Experience Clothing Co., Ltd. (9224)

72 & 82, D.E.P.Z., Savar, Dhaka

26.AUGUST.2014

Identified Priority 1 Concerns

Building B

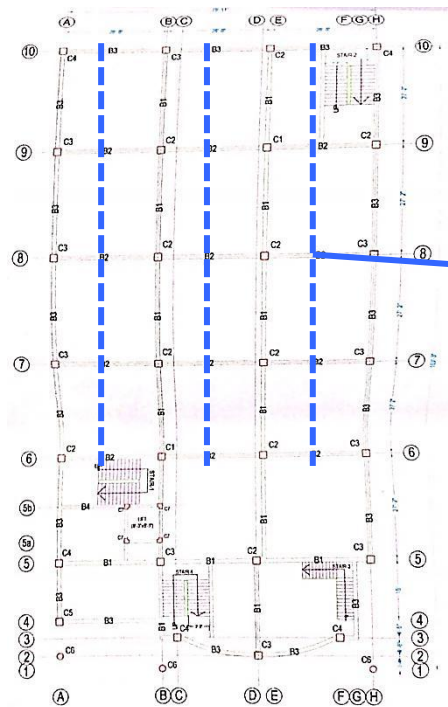
Uncontrolled heavy storage loading was found on 3rd floor at Building B. We believed the loading on storage area to be 5.0 kPa (11 kg per box, 0.60 x 0.40 m footprint, 11 boxes per stack). Loading in these area should be reduced to 2.0 kPa. We require that these items be investigated in a Detailed Engineering Assessment. Loading plans should be displayed in these areas.

3	Priority 1 - The internal columns at ground floor level of Building A between grid line A'-E'/6'-9' appear to be overstressed.	Continue to implement load plan. Carry out fully any and all recommendations of the DEA.	6-months
4	Priority 1 - Uncontrolled heavy storage loading on 3rd floor of Building B.	Reduce stacking height to ensure total load does not exceed 2.0 kPa. A Detailed Engineering Assessment is required to review the design and loads. Factory Engineer to state the maximum weight that is allowed per square meter. Suggest that state the value on notice boards in these areas. (Loading Plans).	Immediate – Now
5	Priority 1 - Uncontrolled heavy storage loading on 3rd floor of Building B.	Adopt some sort of signage/staff guidance to ensure that the maximum weight of storage is not exceeded. (Loading Plans).	6-weeks
6	Priority 1 - Uncontrolled heavy storage loading on 3rd floor of Building B.	Maintain standards of quality control to ensure that storage procedures are correctly followed so that overloading problems do not arise in the future. Maintain and implement Loading Plans.	6-months

Building A

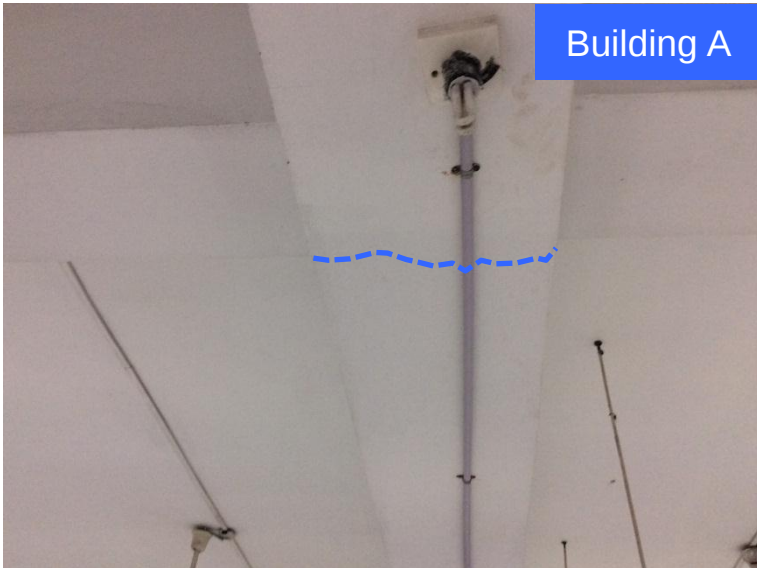
Cracks on 3rd floor beams at Building A. The cause of cracks should be investigated by appropriate methods and then repaired.

Building A

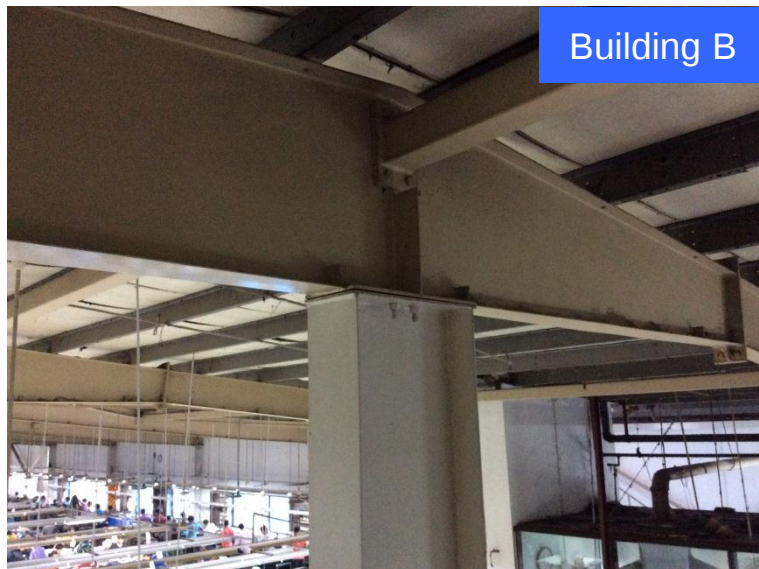
Concerns on the roof slab supporting water tanks. A capacity check of these slabs and all related elements need to be carried out.

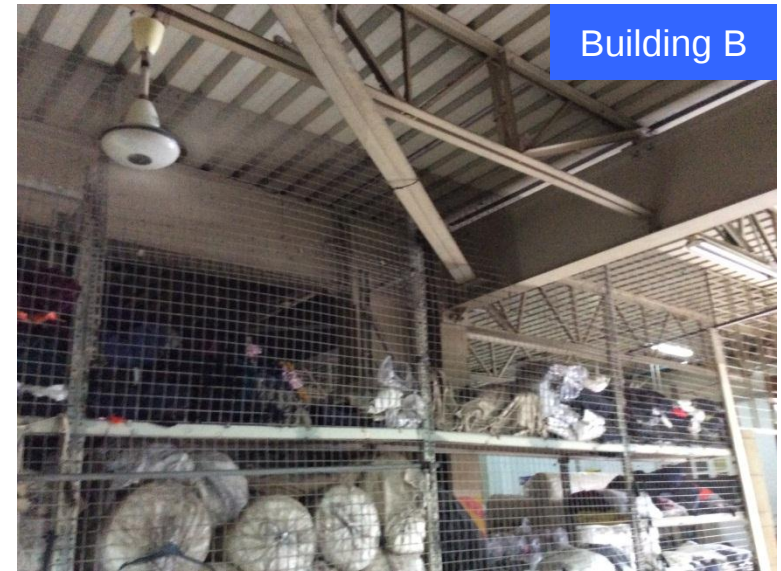
Concern on structural steel connections at Building B. Some bolts were missing at the connections. These items need to be checked and rectified.

11	Priority 2 - Concern with structural steel connections of Building B.	Factory Engineer to check these items in the area identified above and rectify with a suitable methods.	6-weeks
12	Priority 2 - No fireproofing material on any structural steel elements (if required).	Fireproofing material for structural steel element is recommended as suggested in BNBC Codes. Maintain standard of quality control and protection of the fire protection.	6-weeks
13	Priority 2 - Overall stability system.	A Detailed Engineering Assessment of the overall building to be carried out and in particular, stability and foundation aspects should be investigated in detail.	6-weeks
14	Priority 2 - Overall stability system.	Any recommendations of the DEA are to be completed fully.	6-months
15	Priority 3 - Distress due to water ingress.	Factory Engineer to inspect water damaged structures and repair with a suitable methods. Waterproofing on the roof slab is to be applied. Moreover the roof slab drainage system should be investigated and improved.	6-months

Building A

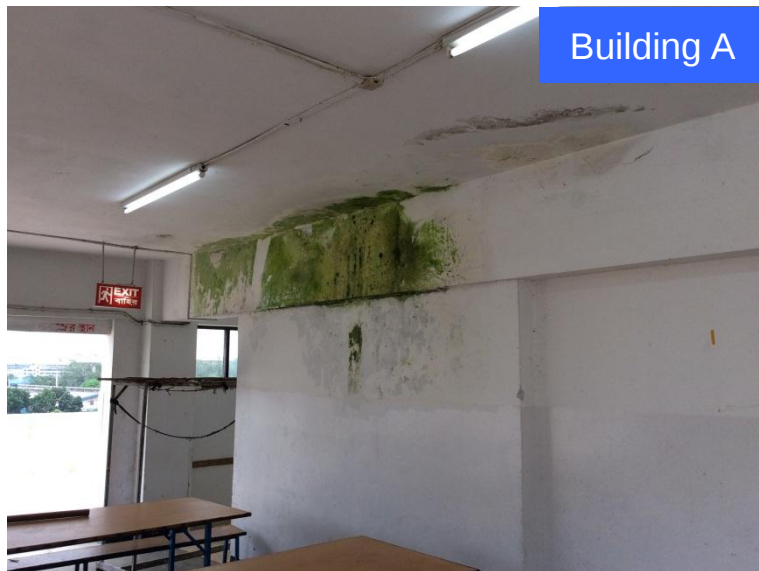
The lateral loading resistance for Building 1, a 5-storey building is provided by moment frame action without any shear wall and the façade brickwork walls lack moment capacity due to their poor connections with the surrounding columns and beams.

We require that the stability of Building A is investigated as part of a Detailed Engineering Assessment.
